751 MARION

Development Objectives

Zoning and Project Goals

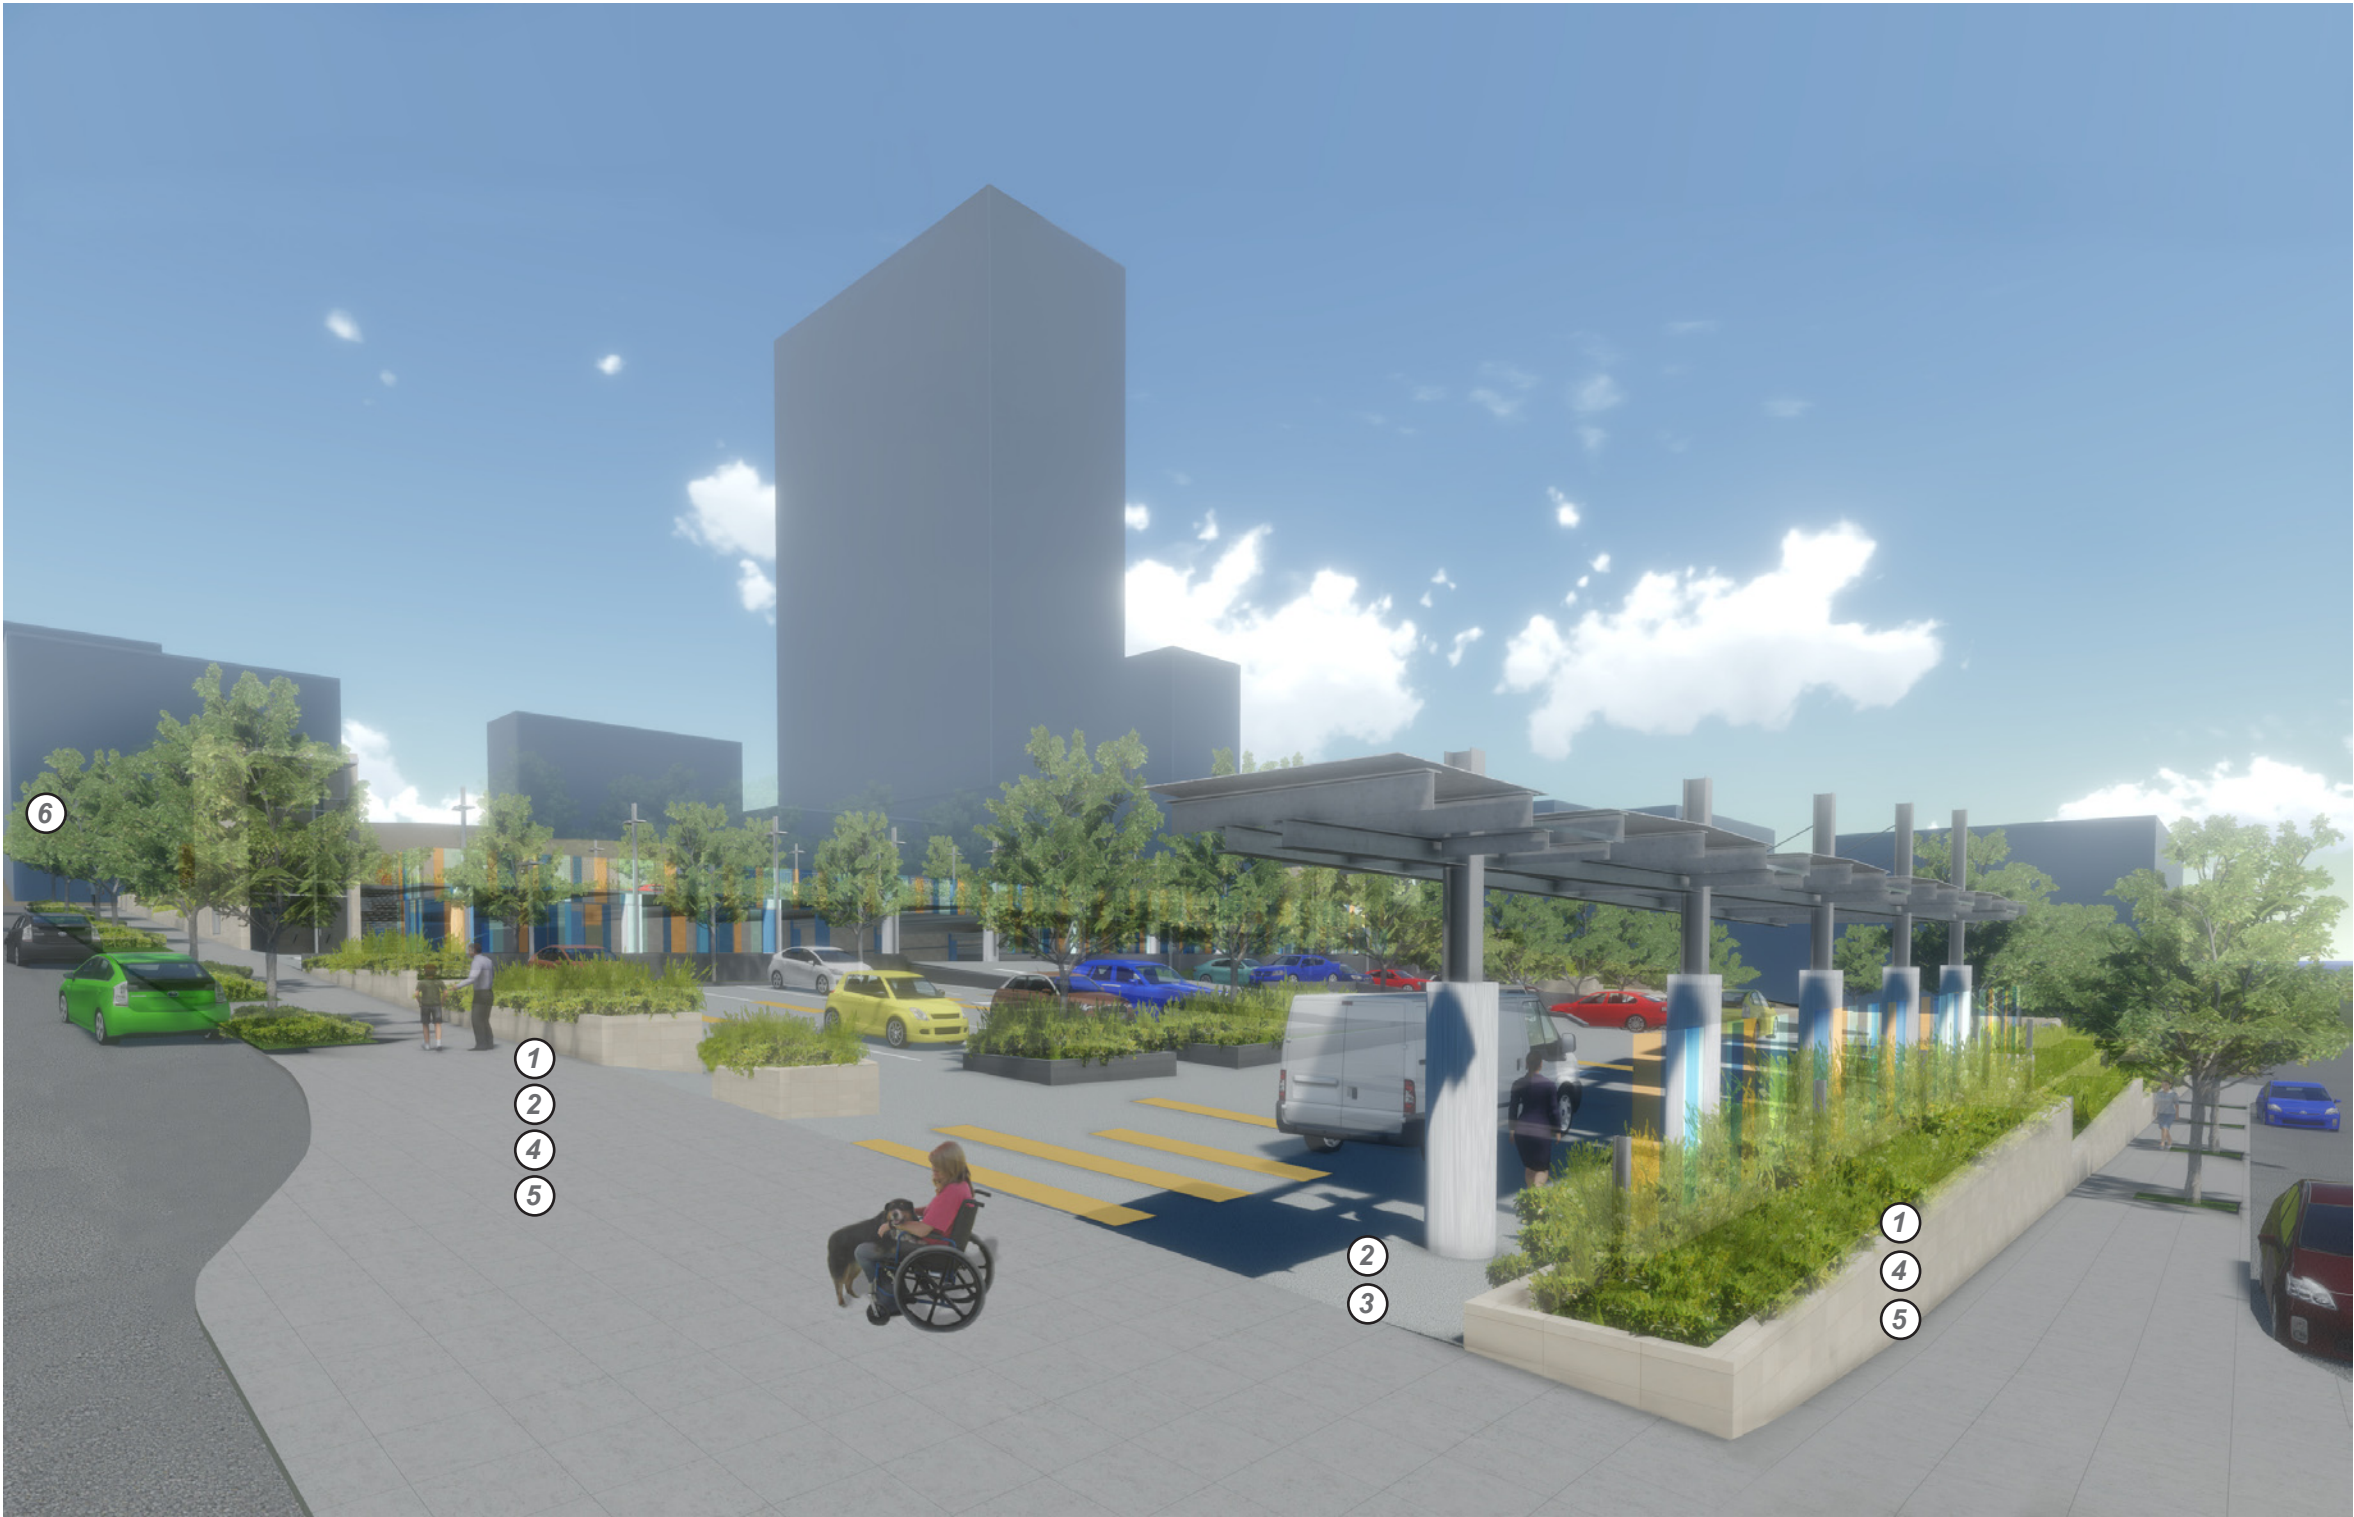
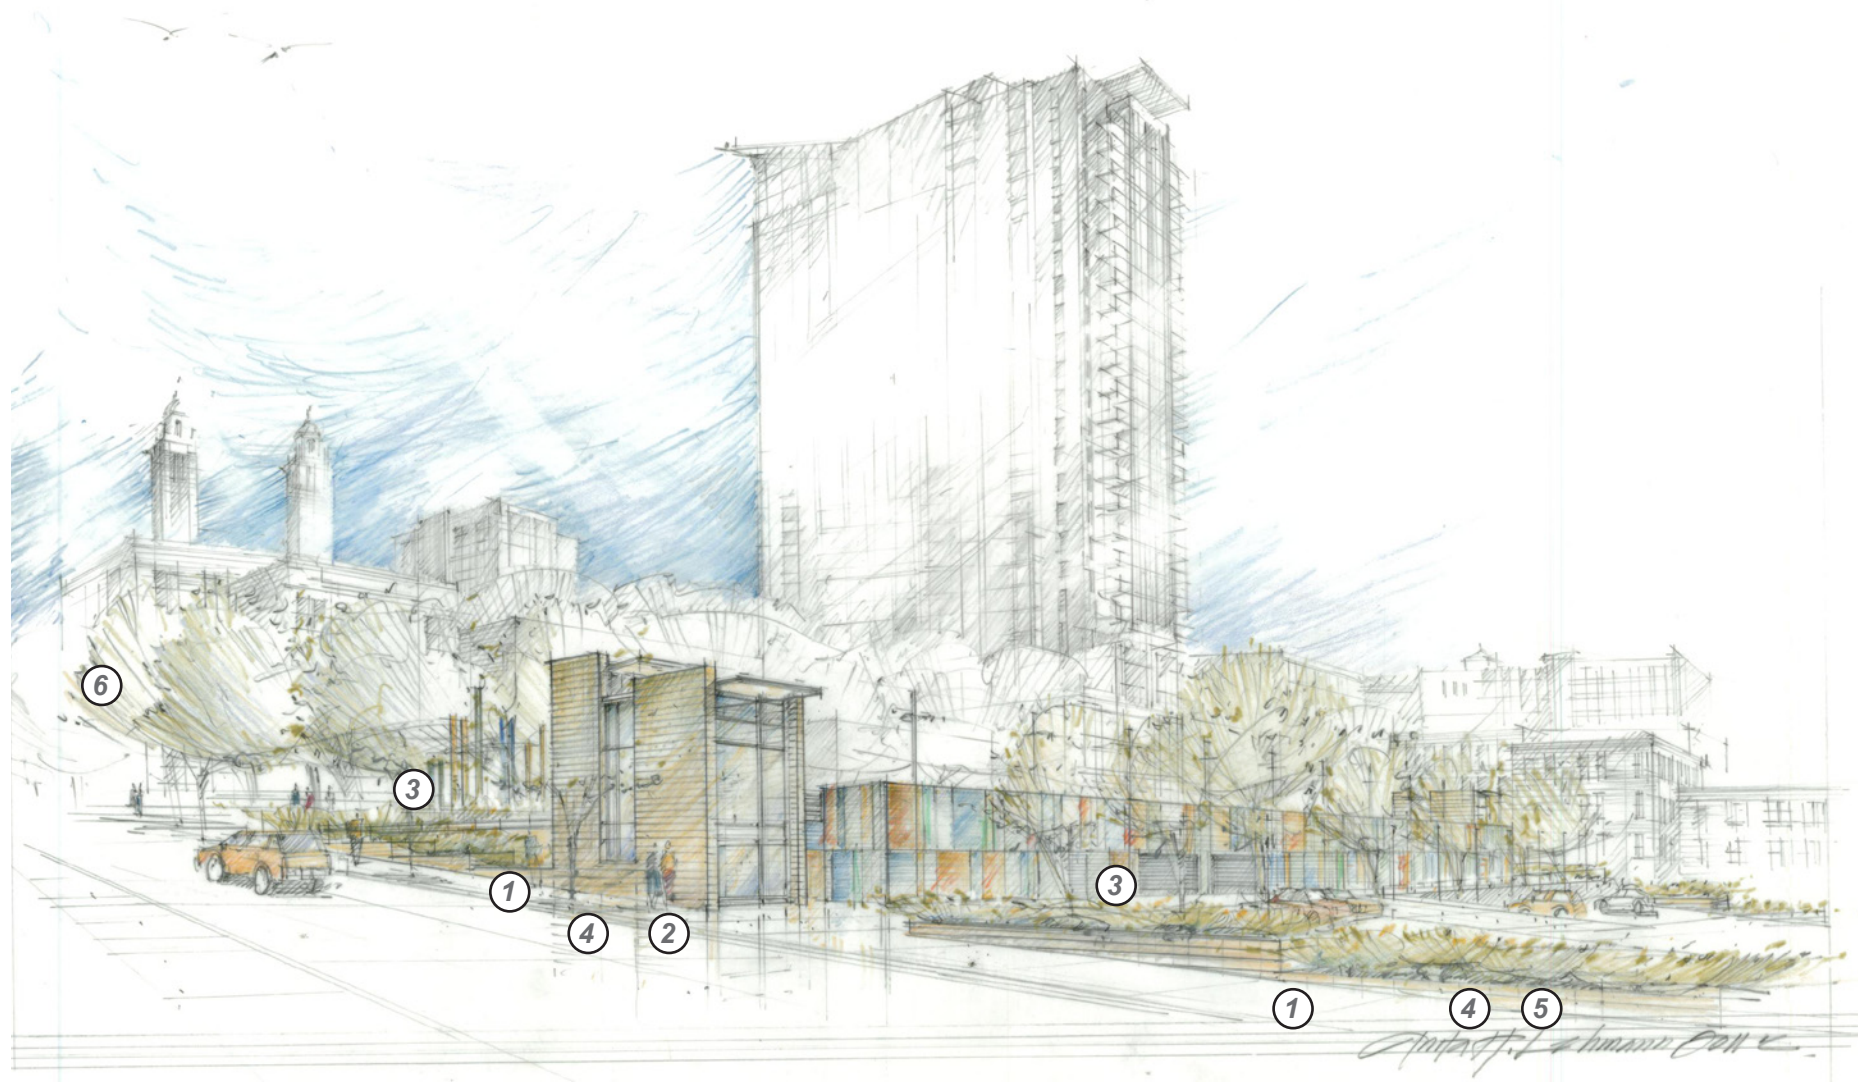
- EDG A-4 Human Activity EDG A-8 Parking and Vehicle Access EDG A-10 Corner Lots**
- ⑥ The previously proposed curb cut and drop-off lane have been eliminated, and sidewalk has been straightened to enhance safety of pedestrian travel on south side of Marion street.

- ② The previously proposed curb cut at Marion has been eliminated. In addition, the previously proposed drop-off lane along south side of Marion has been removed, and the sidewalk has been straightened and widened to provide safer and more continuous path of travel for pedestrians. Passenger drop-off highlights the corner of 7th and Marion. Vertical volumes of stairways anchor street corners at the Alley.
